SUBSURFACE WASTEWATER DISPOSAL SYSTEM APPLICATION

AUGUSTA PERMIT # 1,218 TOWN COPY

WICK JOHNSON, KENNEBEC TOOL & DIE
CHURCH HILL ROAD, AUGUSTA

Re: Final Resolution of Septic System Design

SUBSURFACE WASTEWATER DISPOSAL PLAN

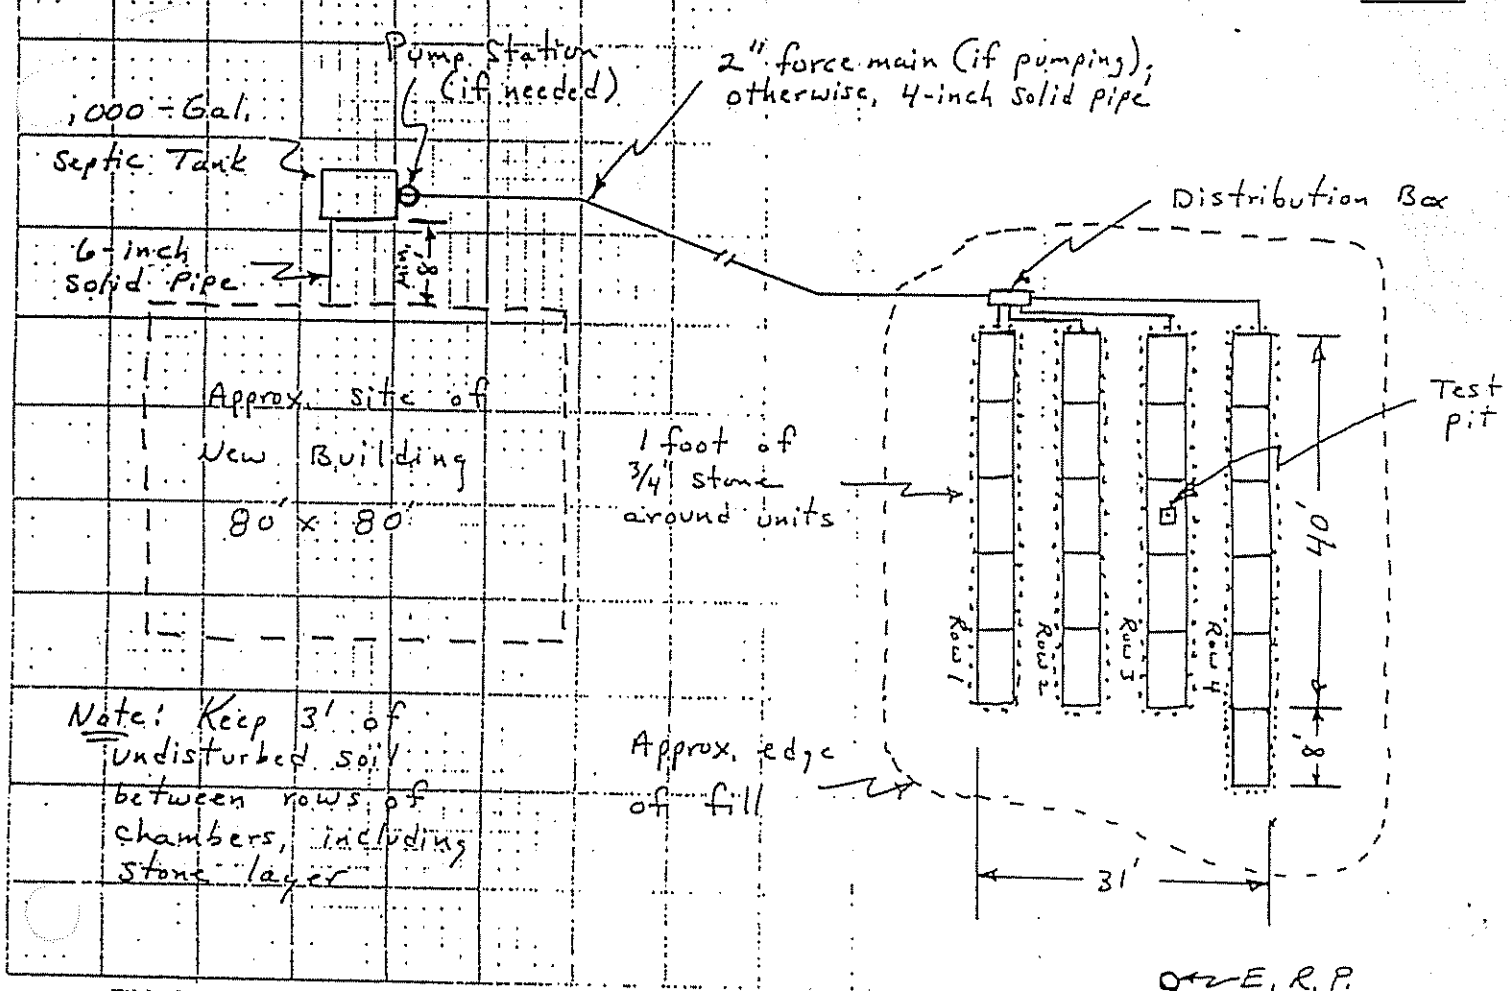
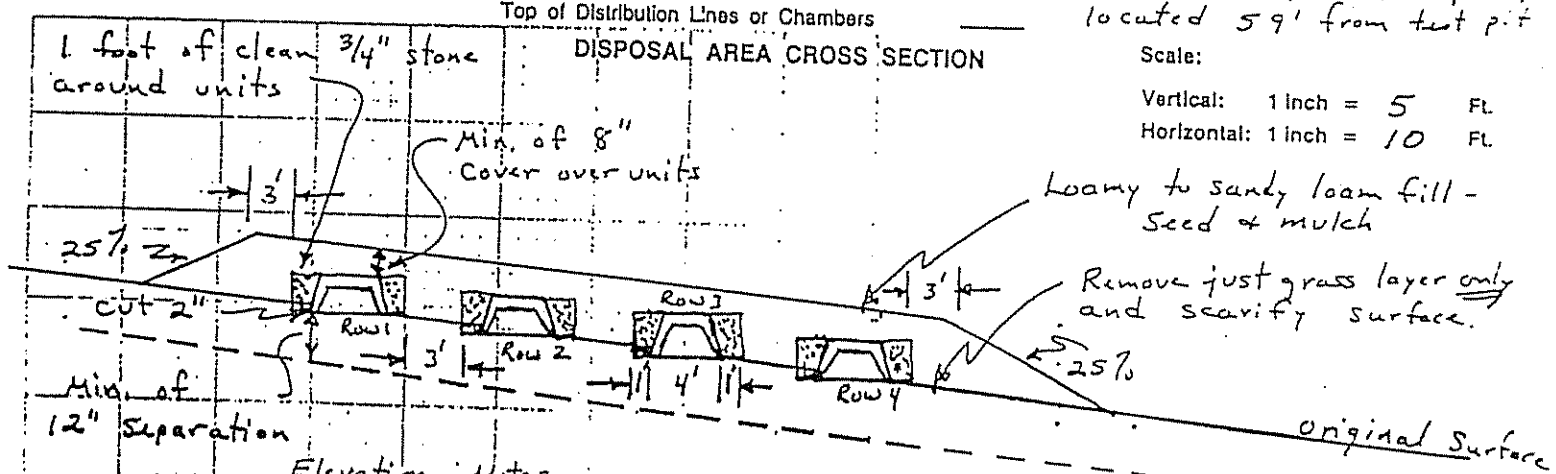
Not mentioned in your letter is the minimum separation distance achieved by this revision. I will need this information to complete our records.

First, the system will be re-installed as originally designed in terms of configuration. The rows of chambers must be raised, and stone (clean, 3/4-inch) placed under the units. The rows must also be placed further apart from one another so that the five-foot separation is maintained between all rows. Row one of the chambers (the highest row) should be raised six (6) inches and kept in its present location. Row two should be raised six (6) inches and moved two feet further from row one, for a total separation of five (5) feet. Row three, raise six (6) inches and move five (5) feet from row two. Row four, move five (5) feet from row three; this row is now over previously undisturbed soil. Remove only the grass (or roto-till the grass into the soil below) and place row four on the new surface of the ground.

As you know, I made two inspections of the septic system as installed by C. M. Builders of Clinton. I am in agreement with Mr. MacCormack, the Plumbing Inspector, that the system was installed too low relative to the elevation reference point that had been established. In addition, insufficient spacing between the rows of chambers is also a problem. The effect of both errors, chambers too low and too close together, is that there is a loss of effective absorption area in the original soil.

By the measurements I took on the site, row one (the highest row) of the chambers is about six inches too low. Row two is also about six inches too low; row three, eight inches too low; and row four, two inches too low. Please note that these figures are not in complete agreement with the recommended elevations. The reason is that these figures represent a minimum separation between the bottom of the chambers and the highest level of mottling in the soil. My original elevations were calculated to provide an extra amount of separation and thus more original soil for absorption of septic wastes.

After discussion of this problem with staff of the Division of Health Engineering, I recommend that the existing chambers be raised by the amount specified above. In addition, an additional row of chambers be added to restore absorptive capacity by the soil. Clean, three-quarter inch stone would be used to elevate the chambers.

Elevations of chambers as currently installed (elevations measured with a clinometer)

Top of chamber
Row 1 (highest row)	-1' 3"
Row 2	-1' 6"
Row 3	-1' 8"
Row 4	-2' 1"

New elevations after system is raised:

Bottom of System	Top of chamber
Row 1	-1' 10"	-0' 9"
Row 2	-2' 1"	-1' 0"
Row 3	-2' 3"	-1' 2"
Row 4	-2' 7"	-1' 6"
